# Service Bulletin

Bulletin No. 2013-01R1  
OEM No. 2013-01R1

## OptiMax and ProXS Product Changes

## Gen II TorqueMaster Gearcase

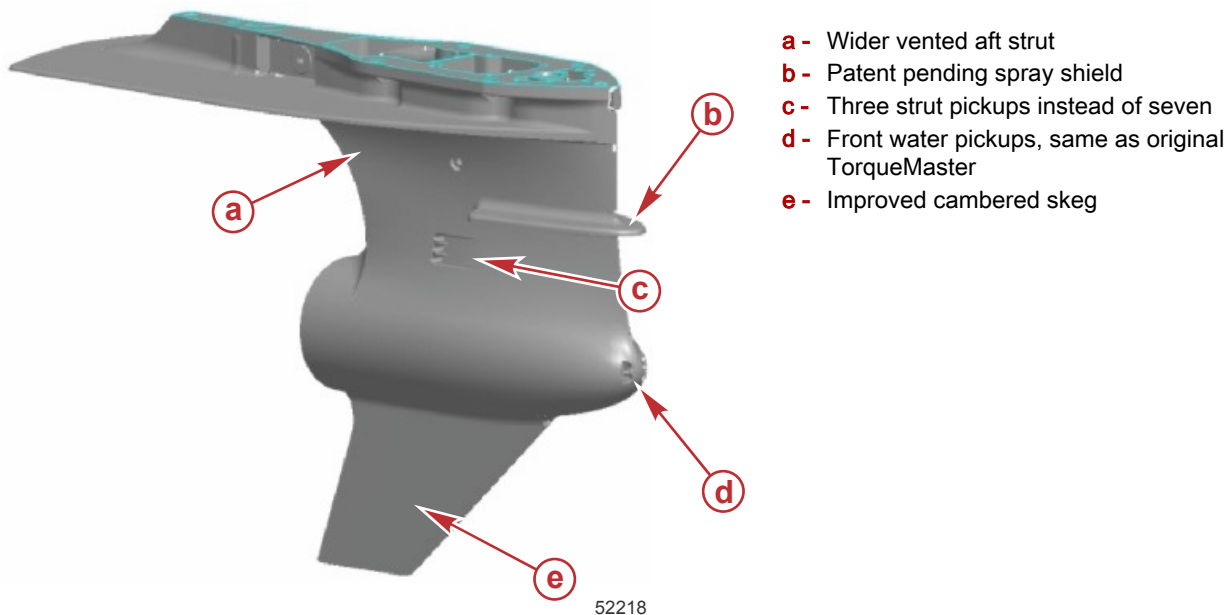
- Production start, December, 2012.
- Starting serial number 1B973744
- Updated performance and durability
- Internal gears and bearings are from the Verado design gearcase to improve durability.
- 1.25 inch propeller shaft to meet surfacing prop requirements
- New housing to allow surfacing prop applications and aft venting of the prop for greater top speed.
- Changes to prop vent holes, mounting height and set back may be required to obtain the benefits of the new Gen II gearcase.

- a** - Wider vented aft strut
- b** - Patent pending spray shield
- c** - Three strut pickups instead of seven
- d** - Front water pickups, same as original TorqueMaster
- e** - Improved cambered skeg

**NOTE:** All Gen II TorqueMaster gearcases must have the increased durability tilt cylinder with a blue cap installed. If a Gen II TorqueMaster gearcase is installed on an engine without the blue cap tilt cylinder (previously discussed), the engine is at risk of a failure if the gearcase strikes a submerged object. Do not replace a Gen I gearcase with a Gen II gearcase. All 3.0L ProXS engines with a serial number 1B974515 and above are built with a blue cap tilt cylinder. Engines with serial number range 1B973744 through 1B974514 may or may not have the blue cap tilt cylinder. Verify the tilt cylinder for the application.
